SUBJECT: GRAND GULF UNIT 1 TECHNICAL SPECIFICATIONS

Comments on Grand Gulf Unit 1 Technical Specifications

TECHNICAL SPECIFICATION PROBLEM SHEET

FIGURE 6.3-77

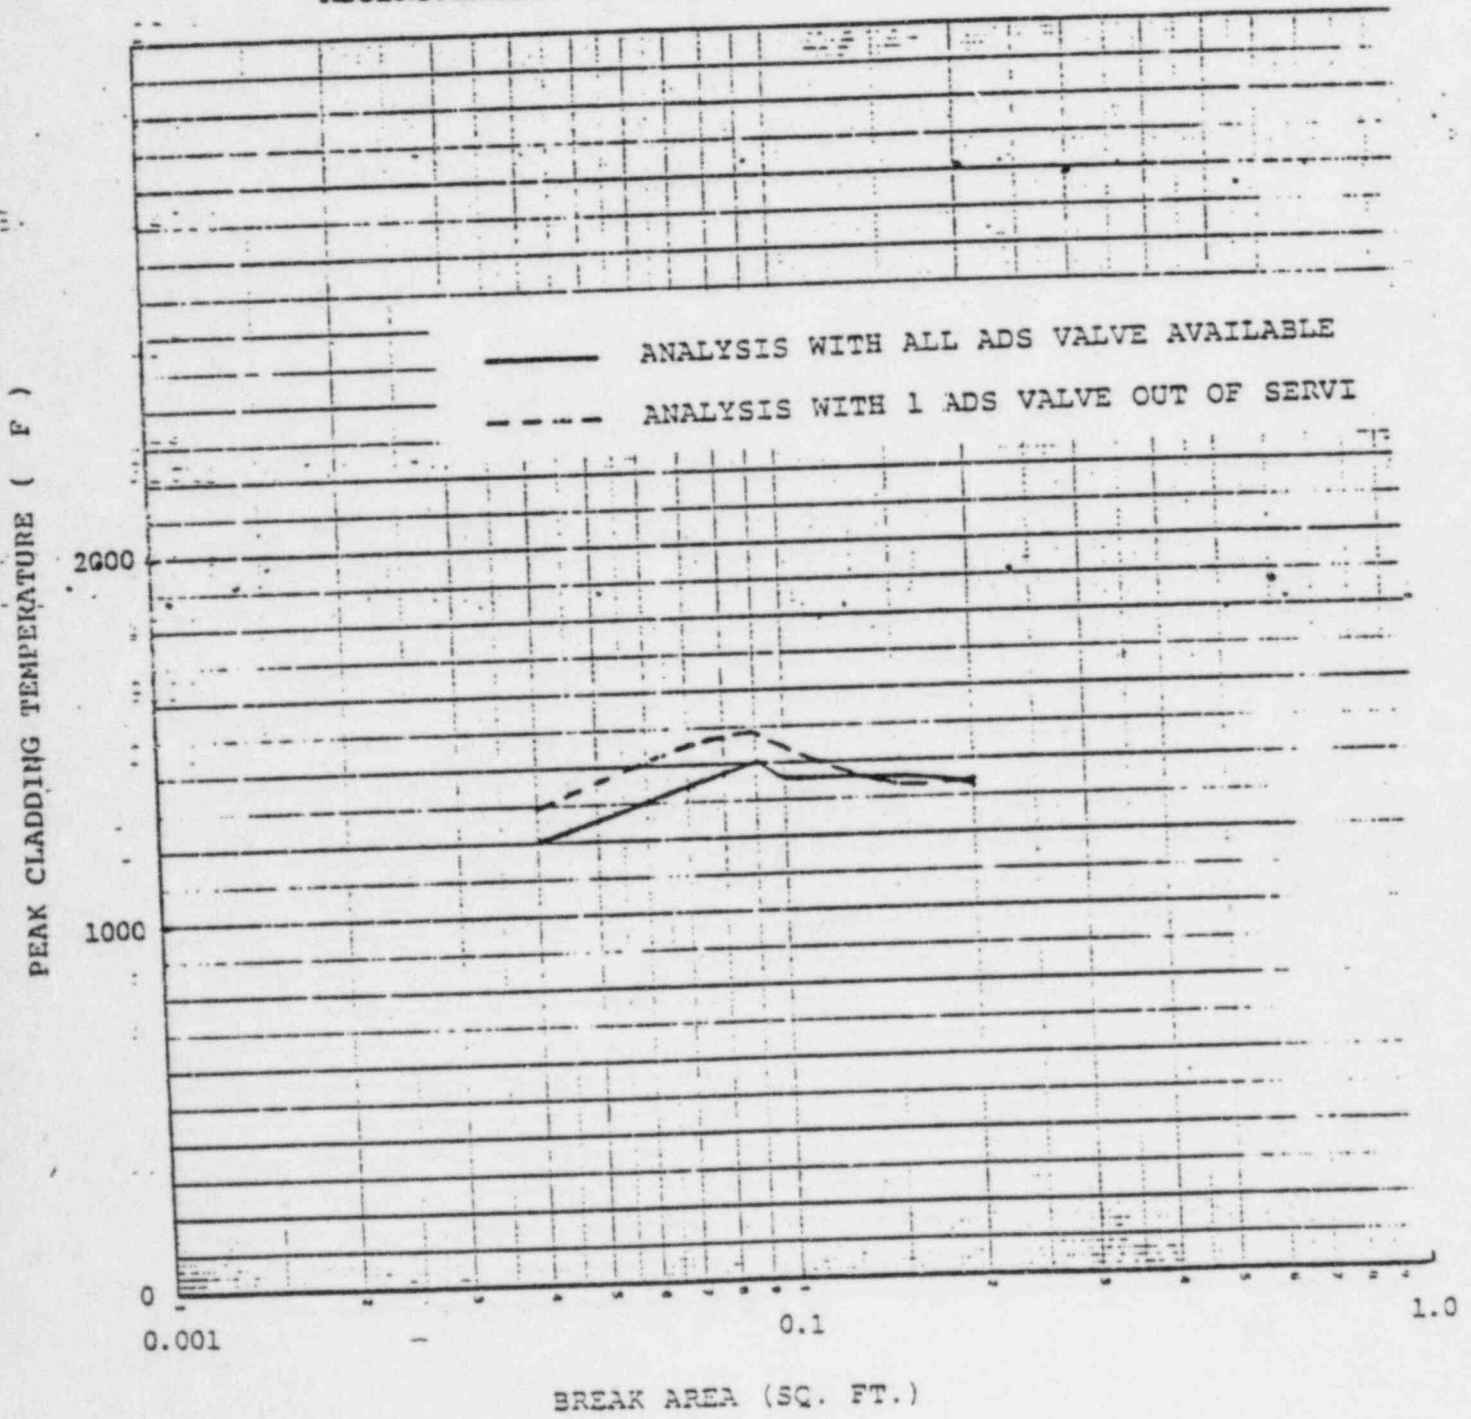
Figure 6.3-77 is a comparison between the two break spectrum calculations for recirculation line breaks. The increase in PCT for an ADS valve out of service is shown to be about 115°F with a maximum PCT of 1477°F occurring at a break size of 0.09 ft<sup>2</sup>. Reactor water level, vessel pressure, heat transfer coefficients and peak cladding temperature versus time for this limiting case are shown in Figures 6.3-78 through 6.3-81.

FIGURE 212.24-7

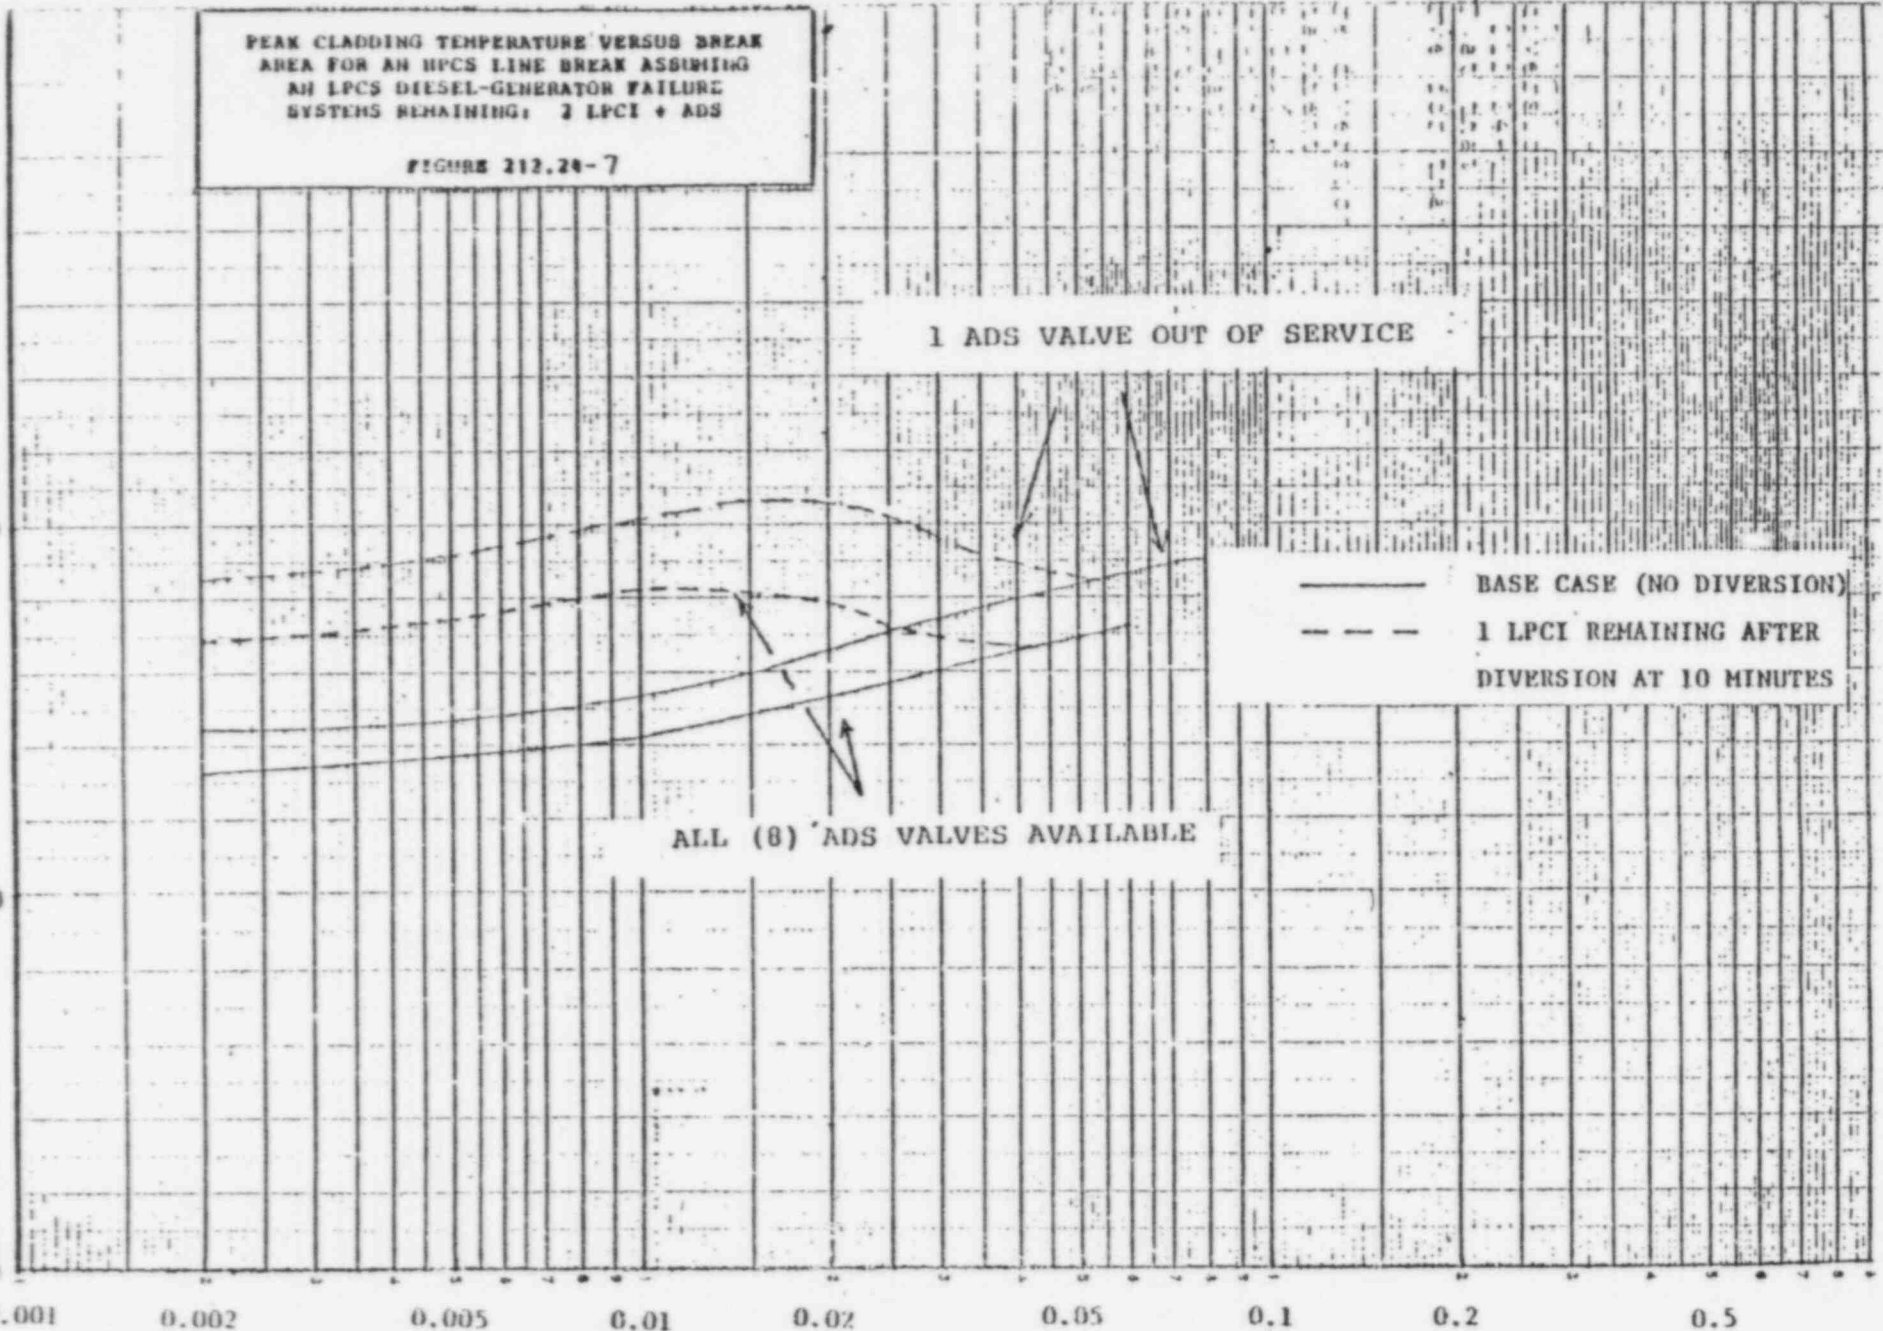
Figure 212.24-7 shows the impact of an ADS valve out of service. The increase in PCT is shown to be about 270°F with a maximum PCT of 2064°F occurring at a break size of 0.015 ft<sup>2</sup>. Reactor water level, vessel pressure, heat transfer coefficients, peak cladding temperature, and ECCS flow versus time for this limiting case are shown in Figures 212.24-8 through 212.24-12. Since the PCT for this limiting case is still below the 2200°F limit, no change in the operating MAPLEGR limit is required due to an ADS valve out of service, to meet the 10CFR50.46 licensing limits.

USE OF ABSOLUTE INSTR. FOR HIGH DRYWELL PRESS TRIPS

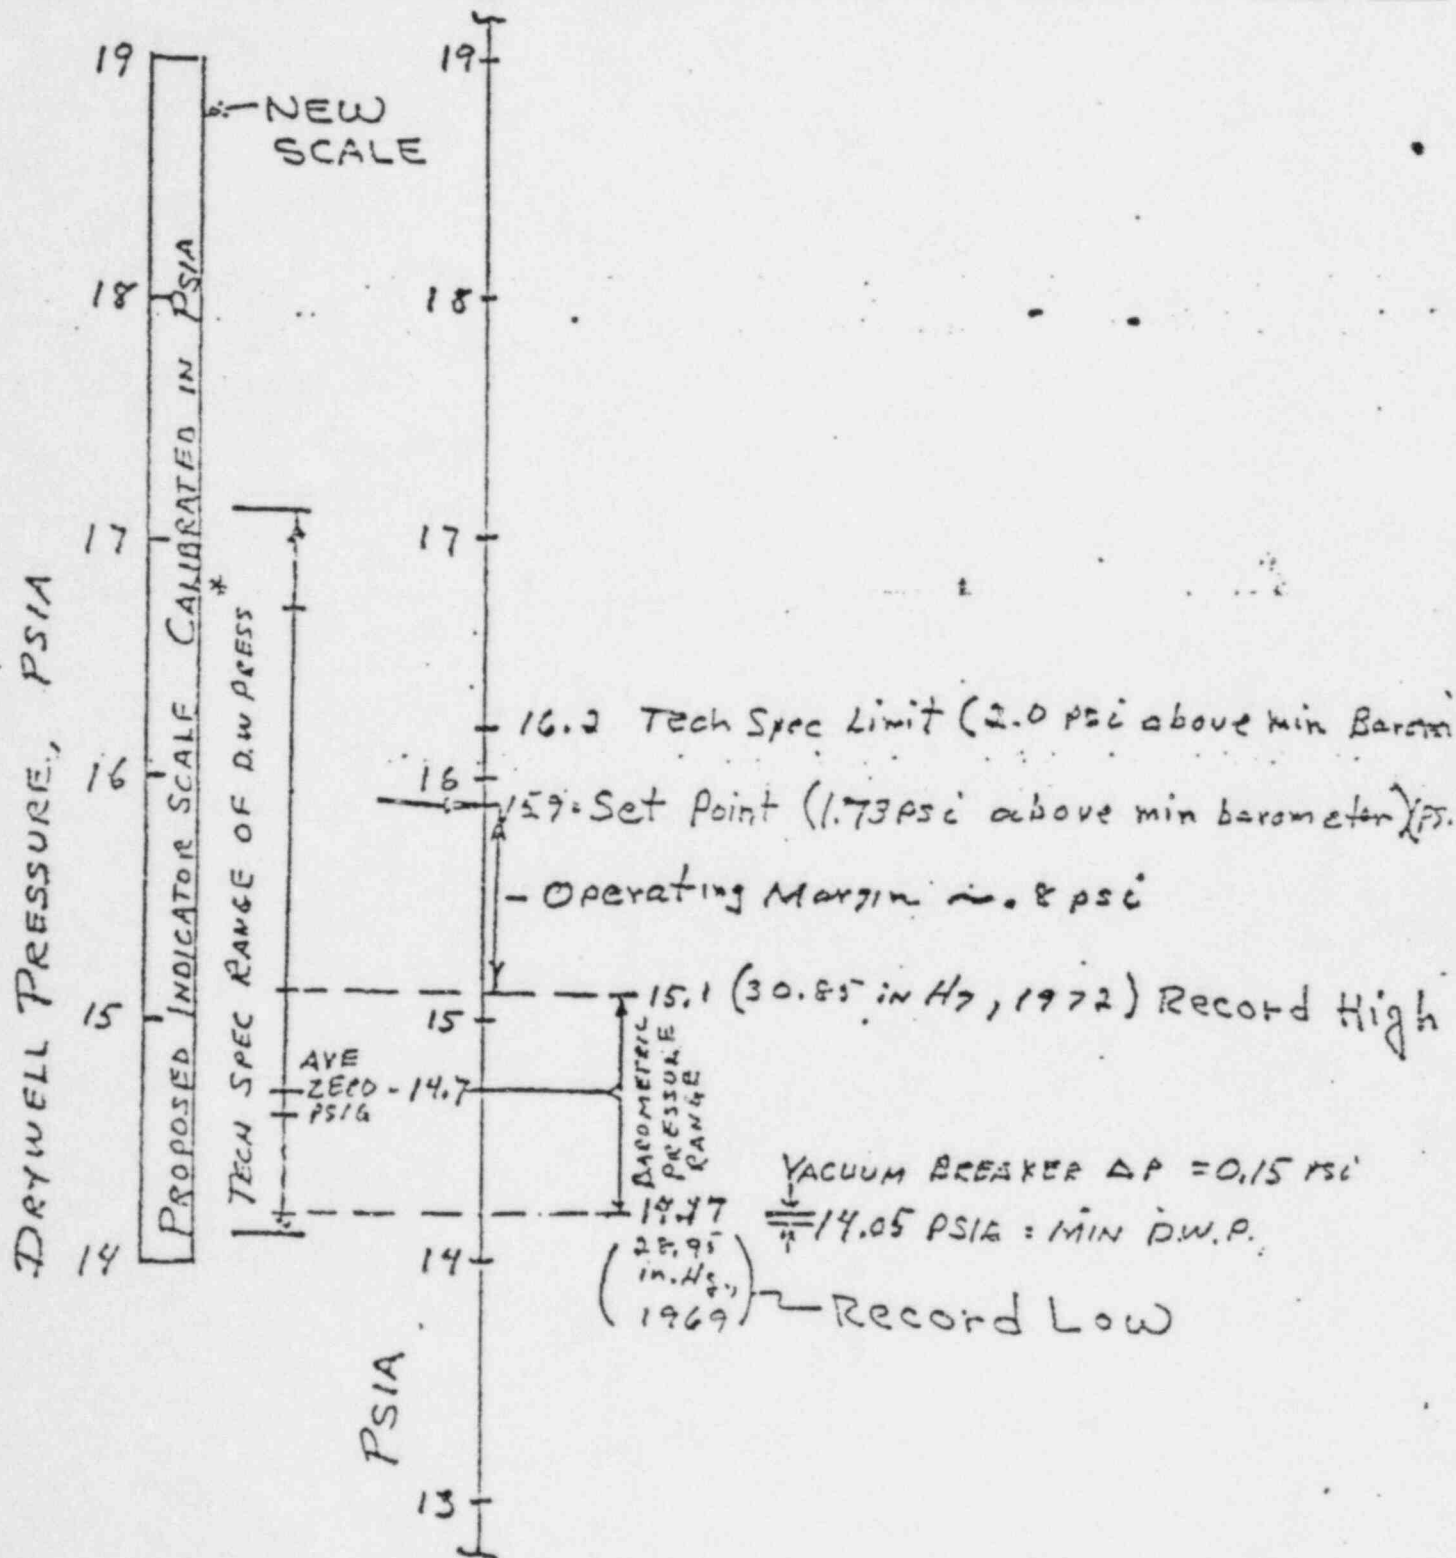
Nominal set point of this absolute press instr can be reduced to  $\geq .5$  psi above maximum drywell operating press., if necessary, to accommodate barometric pressure changes. This margin provides adequate spurious trip avoidance. A larger margin should be used if feasible.

This lowered nominal set point is needed to accommodate low barometric pressures vs the 2 PSIG Analytic limit. In order to preserve the instrument margins (accuracy, calibration and drift) for low barometric pressure conditions the nominal set point must be lowered such that the specified nominal in the set point table is not exceeded, in terms of PSIG, when the barometer is at its minimum.

SUGGESTED DISPOSITION  EXPEDITED DISPOSITION  
 Add note to B21-694 on drawing 22A3856AA and paragraph 4.3.11.9 on drawing 22A377TAE and any other applicable drawing stating that nominal setpoint of this absolute pressure instrument can be reduced .5 PSI above maximum drywell operating pressure if necessary to accommodate barometric pressure changes. This margin provides adequate spurious trip avoidance. A larger margin should be used if feasible.
